<b>JRPP No.</b>	2010HCC030
<b>DA No.</b>	1601/2010
<b>Proposal</b>	Telecommunication Facility
<b>Property</b>	Lot 1 DP 114469
<b>Applicant</b>	Telstra Corporation C/-Urbis Services
<b>Owner</b>	Hunter Water Corporation
<b>Lodged</b>	17 September 2010
<b>Value</b>	\$250,000.00
<b>Consent Authority</b>	Joint Regional Planning Panel
<b>Integrated Bodies</b>	Mine Subsidence Board
<b>Referral Agencies</b>	None
<b>Submission</b>	Thirty five (35)
<b>Recommendation</b>	Refuse
<b>Public Notification</b>	23 September to 8 October 2010
<b>Report By</b>	David Lovell, Senior Development Planner, Lake Macquarie City Council

## Joint Regional Planning Panel – Assessment Report

Figure 7- shows the possible indoor hand held coverage from the co-location Optus site (blue), in comparison to target area which is delineated by a pink line (extract-Urbis SoEE).

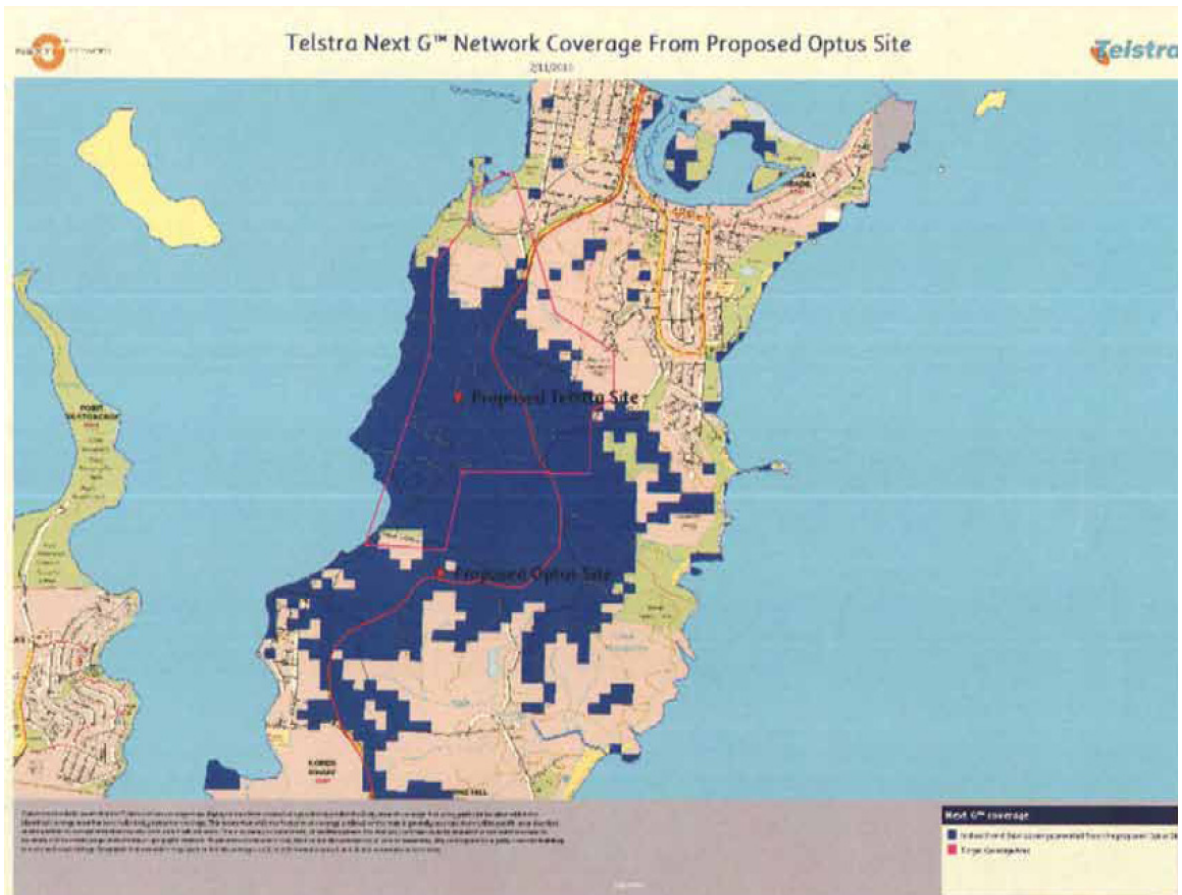
Figure 7 demonstrates that the co-located option retains coverage to the majority of the areas of Murrays Beach, North Wallarah Peninsula, the Pacific Highway and Cams Wharf.

When Comparing figures 7 and 8, the co-location option does not provide full coverage to the target (pink) area nominated by Telstra. Two areas, (Area A and Area B), figuratively shown at figure 10, are not covered. To consider whether co-location is practical and viable, Council undertook a desktop study of these two locations.

Figure 9-shows areas of non-coverage under the co-location options overlaid land use mapping *Lake Macquarie Local Environmental Plan 2004* (extract from Council)

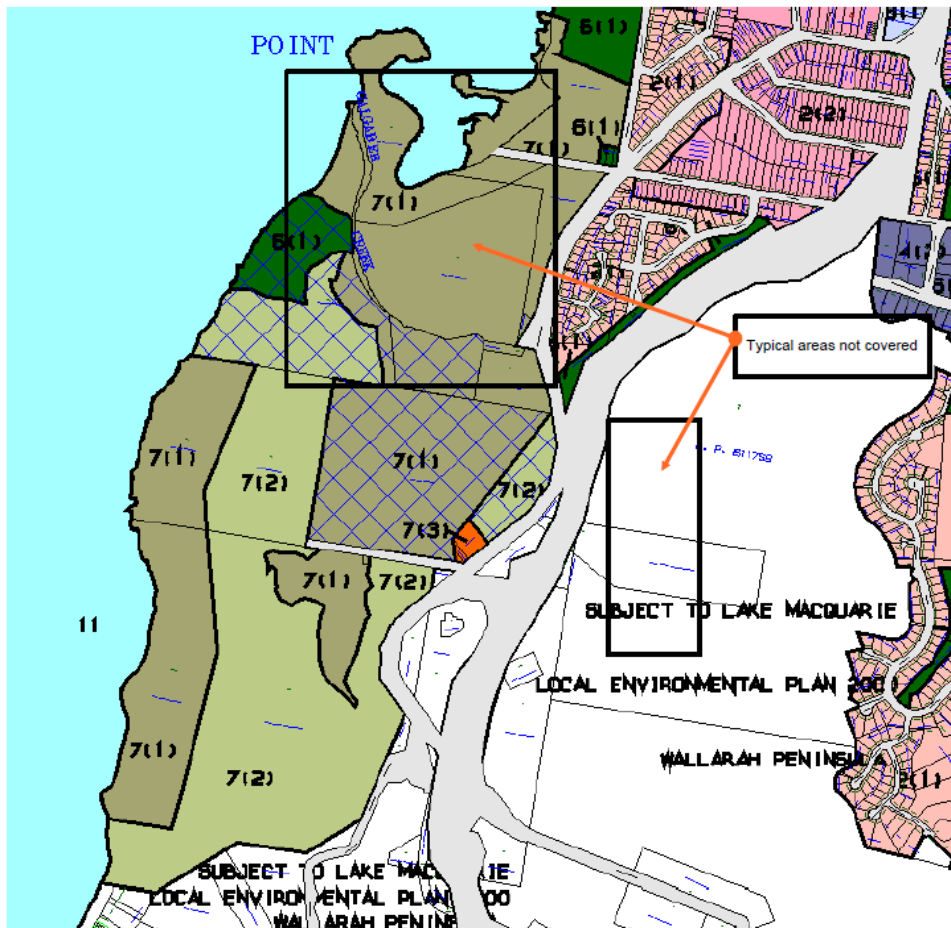
In this regard, not providing the optimum of *in-building* mobile phone coverage to these lands, under a co-location option, is not considered to be an inappropriate compromise.

Area B is within *Lake Macquarie Local Environmental Plan 2000* and zoned 10(a) investigation. This is a small portion of the total target area where *in-building* mobile phone coverage may be compromised.

Pursuant to *North Wallarah Peninsula Master Plan* this area is identified for a mix of housing and open-space conservation. In contrast to Area A, this area is identified for a higher population, however in comparison to the overall desired target area, a potential compromised *in-building* Telstra service to this area on balance is not considered to be an impractical compromise.

Figure 11-locaiton of future residential development likely in context to the proposed site.

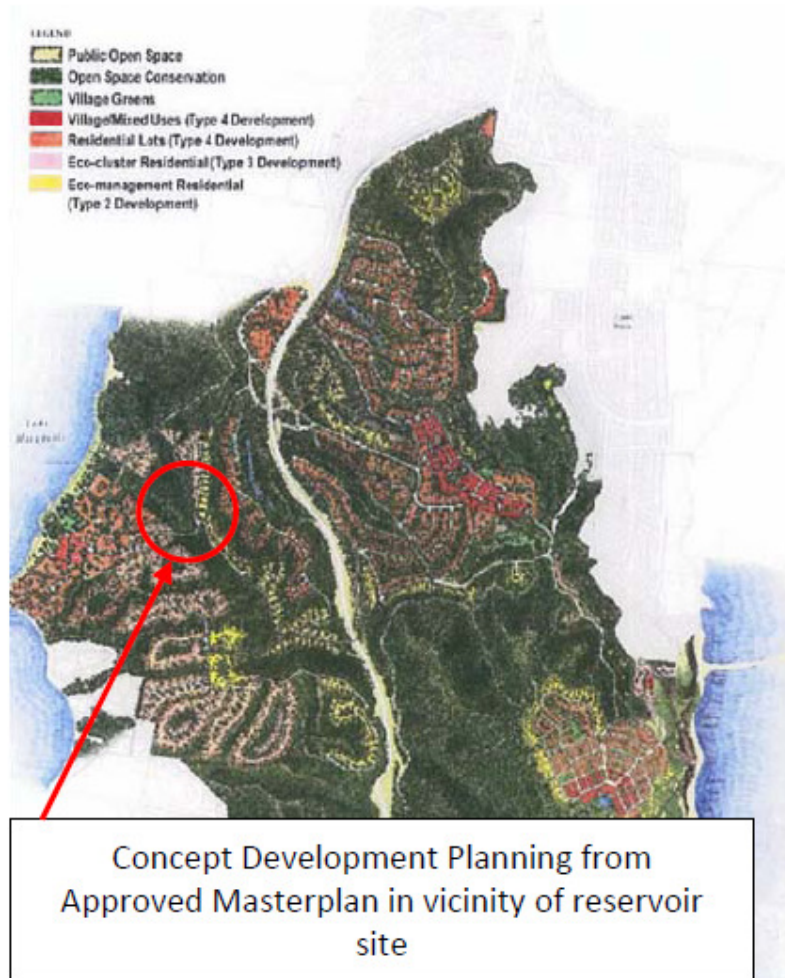
- The development is located on a prominent ridgeline within the Lakeside Ridge Precinct. Future static views of the site will be observable from this precinct between the ridgeline and the Pacific Highway, to the north, east and south. Dwellings are proposed to be located in an area ranging from 50 to 500m from the site. Visual impacts with the removal of vegetation for roads and housing is likely to make the site significantly more observable than current conditions would promote.

1. The proposed development site in the future will not be relatively separated from sensitive land uses. The facility will eventually be centrally located within a residential area inclusive of a planned village 400 m northeast of the site.

2. Dwellings are likely to be as close as 50 m to the proposed site and share common property boundaries. The planned village and residential areas are likely to have direct static views of the facility above the tree canopy, particularly as the canopy is further selectively cleared for buildings and infrastructure such as roads.

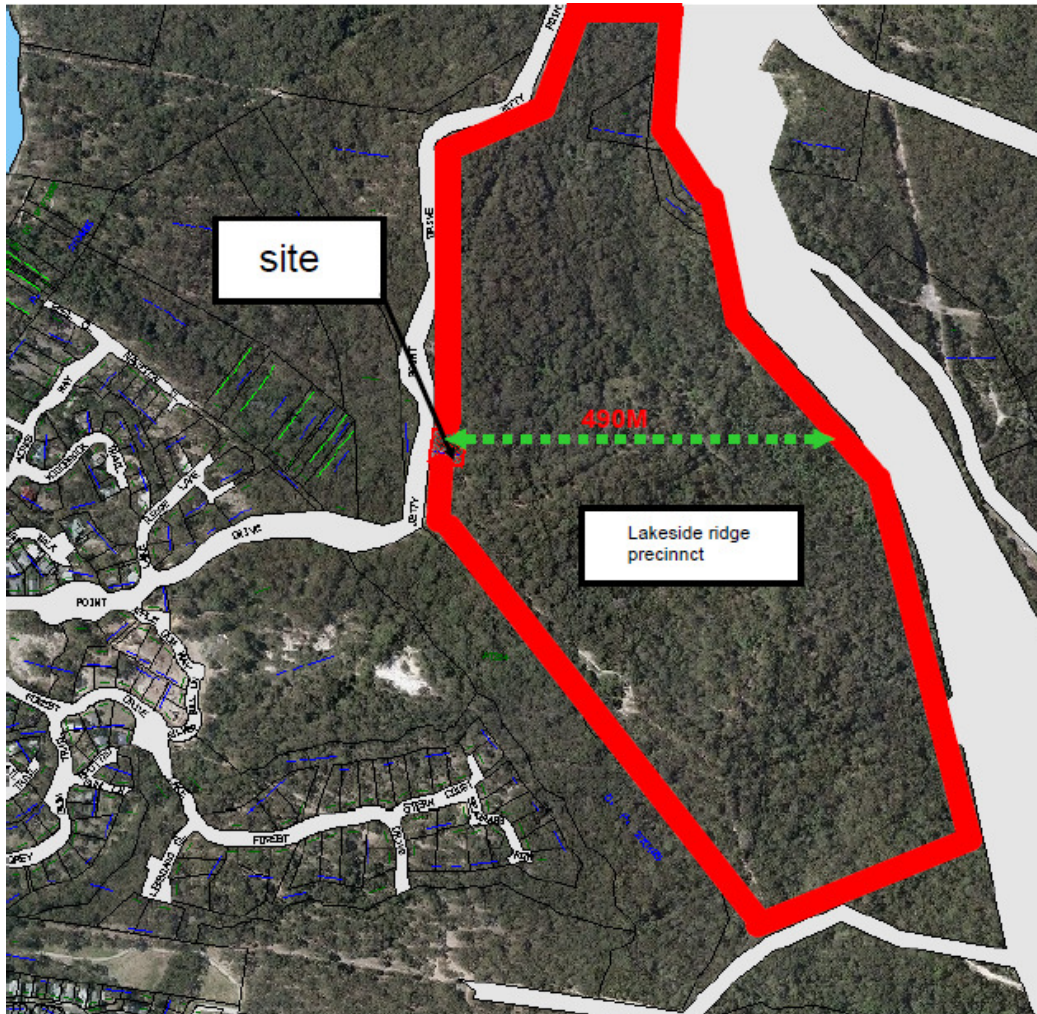
3. The application has not adequately addressed or demonstrated the likely visual impacts of the development on the Lake Sector and Lakeside Ridge Precinct (the lands north-east, east and south east, between Jetty Point Drive and the Pacific Highway) as shown in figure 165 below.

4. The slim-line design of the development in managing distance views can be effective. However, in this case, the use of a slim-line design will not reduce the future visual impacts of the development obtained close by to the site, mainly from the Lakeside Ridge Precinct which range from between 50 to 500 metres.

The application has not demonstrated that the telecommunication facility is designed and sited to minimise visual impact (principle 1).
